# Access Compliance Report

## Public Rights-of-Way

Intersection ID: 27494	Main Street: BALLANTYNE COMMONS PY	Cross Street: SUMMIT COMMONS BV	Location: NE
ADA ID: 4519470C0D1E	Ramp Type: Perp	Initial Pass/Fail: Fail	Overall Compliance: No
Severity Score: 10			
Codes/Mitigation Info/Possible Solution		Field Measurements/Component Compliance

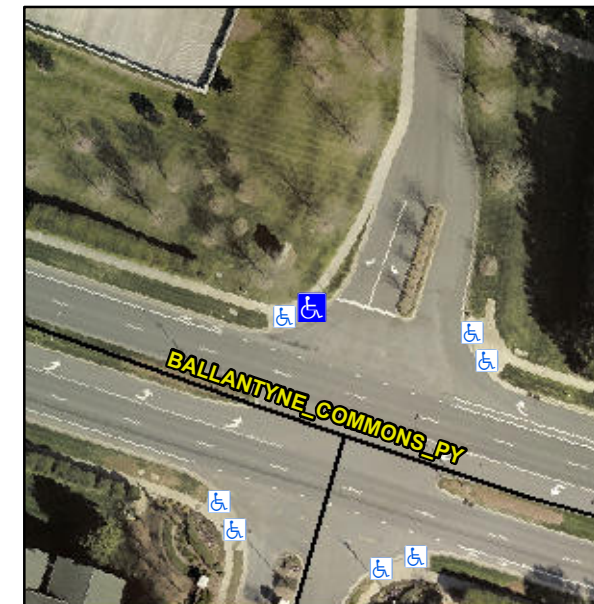
**R304.5.1, R304.5.3**

Compliance	Description	Data	Compliance	Description	Data
N/A	Ramp Length (in)	121.0	Yes	Ramp Slope (%)	7.5
No	Ramp Width (in)	40.0	No	Ramp XSlope (%)	3.5
N/A	Flare Type LT	N/A	N/A	Flare Type RT	N/A
N/A	Flare Slope LT (%)	N/A	N/A	Flare Slope RT (%)	N/A
N/A	Flare Traversable LT?	N/A	N/A	Flare Traversable RT?	N/A
N/A	Landing Length (in)	N/A	N/A	DWS Provided?	N/A
N/A	Landing Width (in)	N/A	N/A	DWS Contrast?	N/A
N/A	Landing Slope (%)	N/A	N/A	DWS Length (in)	N/A
N/A	Landing X Slope (%)	N/A	N/A	DWS Full Width?	N/A
N/A	Landing Curb? (Y/N)	N/A	N/A	DWS Offset (in)	N/A
N/A	Shared Landing?	N/A			
N/A	Gutter Ponding?	N/A	N/A	Gutter Slope (%)	N/A
N/A	Gutter Lip Ht (in)	N/A	N/A	Gutter X Slope (%)	N/A
N/A	Painted X Walk1?	No	N/A	Painted X Walk2?	N/A
	X Walk 1 Direction	To SE		X Walk 2 Direction	N/A
N/A	X Walk 1 Width (in)	N/A	N/A	X Walk 2 Width (in)	N/A
	X Walk 1 Slope (%)	2.9		X Walk 2 Slope (%)	N/A
	X Walk 1 X Slope (%)	0.5		X Walk 2 X Slope (%)	N/A

**Remove & Replace Entire Ramp.**
